**CITY OF TEMPE  
DEVELOPMENT REVIEW COMMISSION**

**Meeting Date: 04/09/2013  
Agenda Item: 2**

**ACTION:** Approval of a General Plan Density Map Amendment, a Zoning Map Amendment, a Planned Area Development Overlay and a Development Plan Review for THE NEWPORT (formerly SKYVIEW AT TEMPE), located at 1102 E Weber Drive. The applicant is Joseph Risi of American West Development.

PAD13003

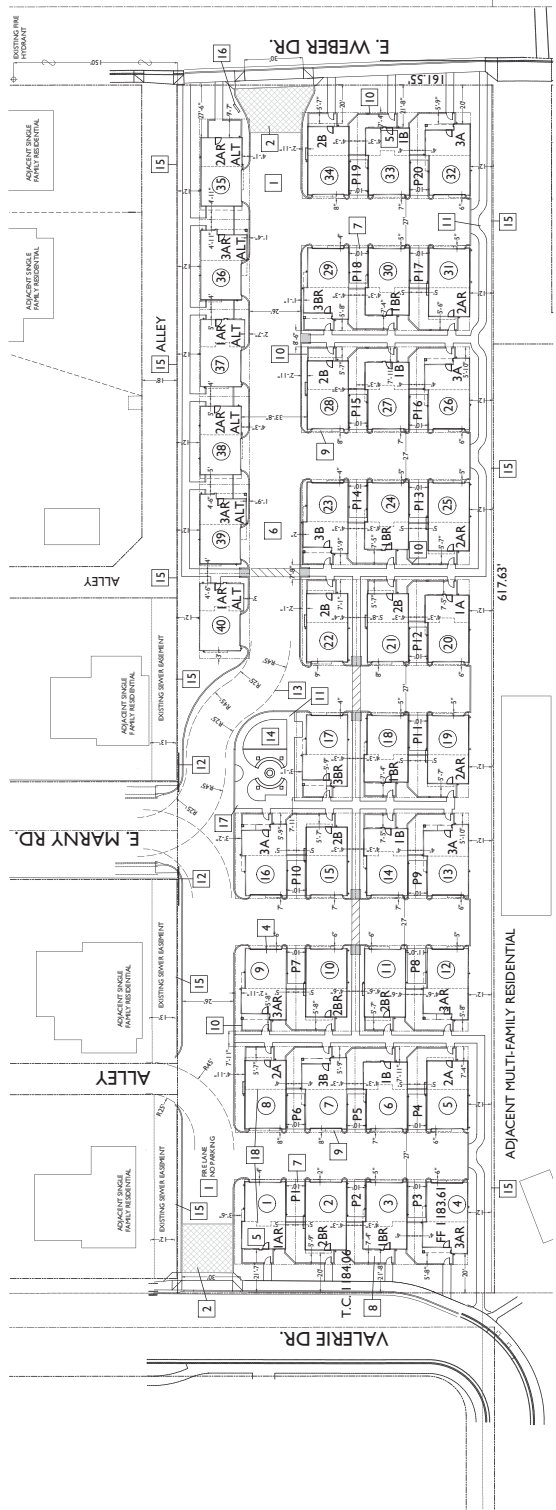
7. Provide 5'-6" wide public sidewalk along arterial roadways, or as required by Traffic Engineering Design Criteria and Standard Details.
8. Screen mechanical equipment from public view (from perimeter of site). Verify height of equipment and mounting base to ensure that wall height is adequate to fully screen the equipment.

9. Provide gates of steel vertical picket, steel mesh, steel panel or similar construction. Provide gates of height that match that of the adjacent walls. Review gate hardware with Building Safety, Refuse, Police and Fire staff to resolve lock and emergency ingress/egress features that may be required.

10. Provide upgraded paving at each driveway consisting of unit paving. Extend this paving in the driveway from the right-of-way line to 20'-0" on site and from curb to curb at the drive edges. From sidewalk to right-of-way line, extend concrete paving to match sidewalk.

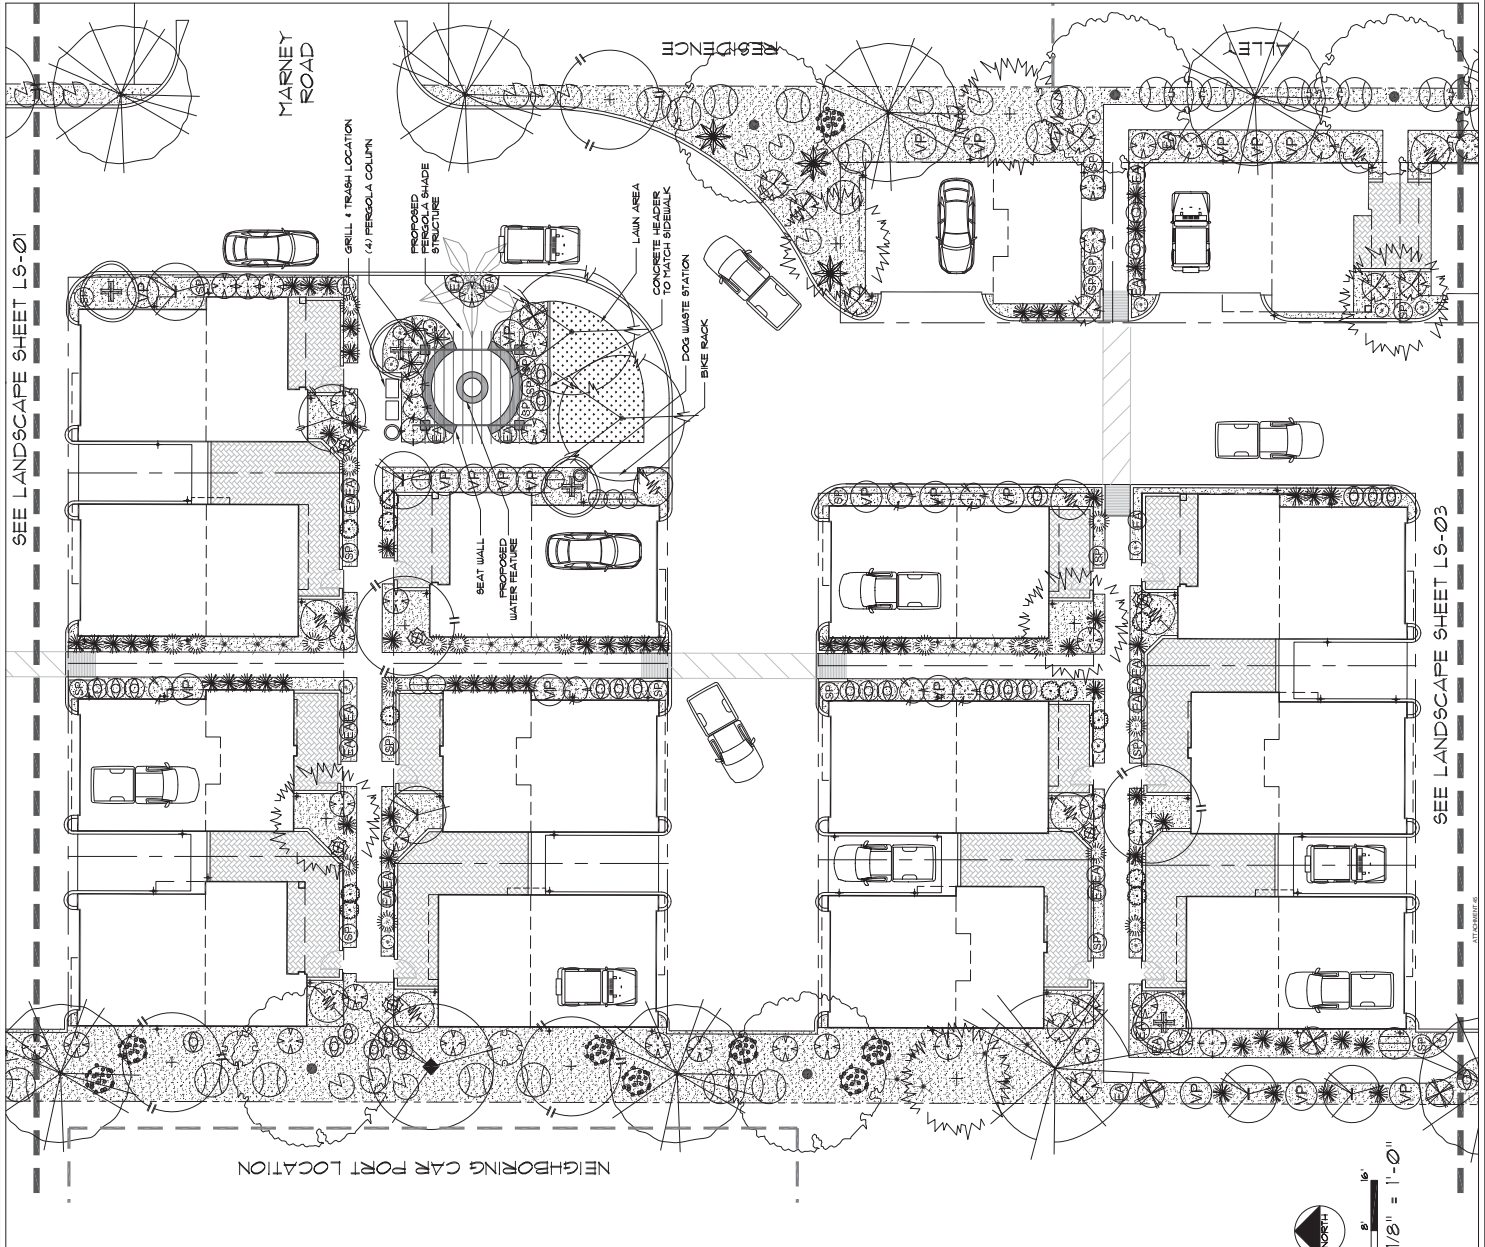
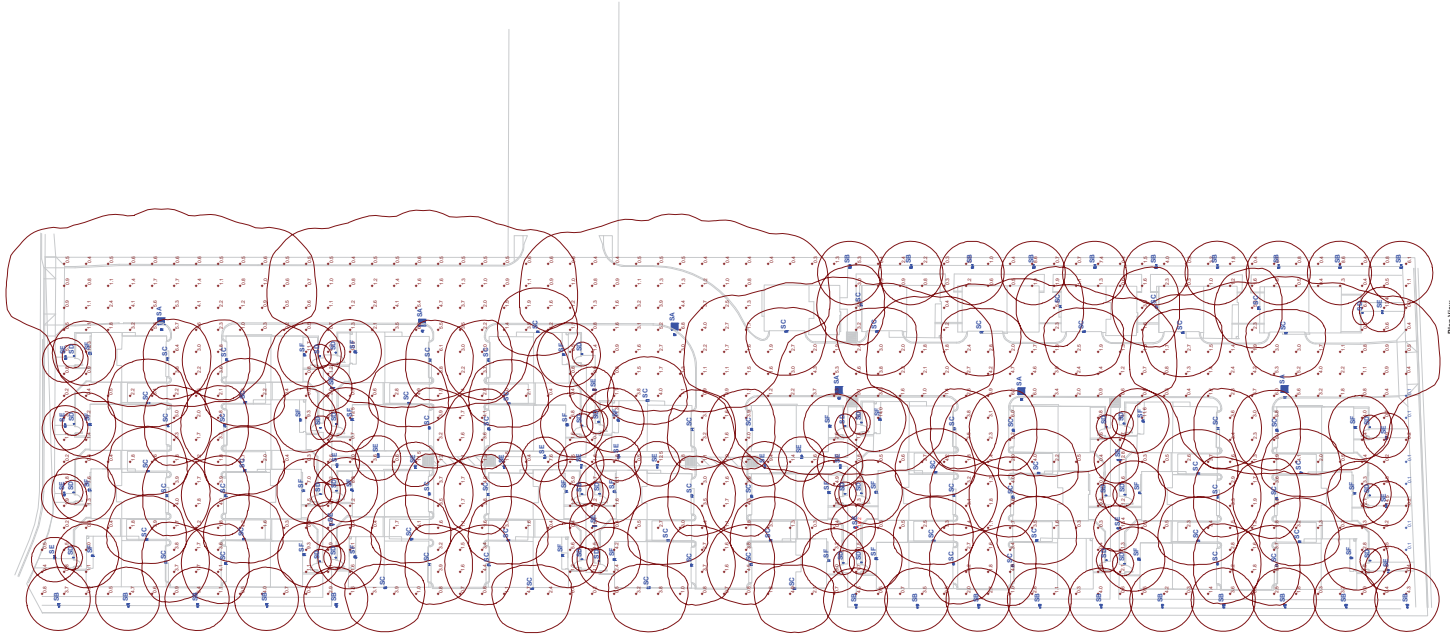
22. The plant palette is approved as proposed and specified on the landscape plan. Any additions or modifications may be submitted for review during building plan check process.

23. Continuing care condition, covenant and restriction for all of the project's landscaping, shall include requirement to maintain all perimeter buffer trees and street front trees per the approved landscape plan.

27. Trees shall be planted a minimum of 12'-0" from any existing or proposed public water or sewer lines located on-site. Trees near the main water or sewer lines located within the right of way shall be planted at least 20'-0" away. Final approval subject to determination by the Public Works, Water Utilities Division.
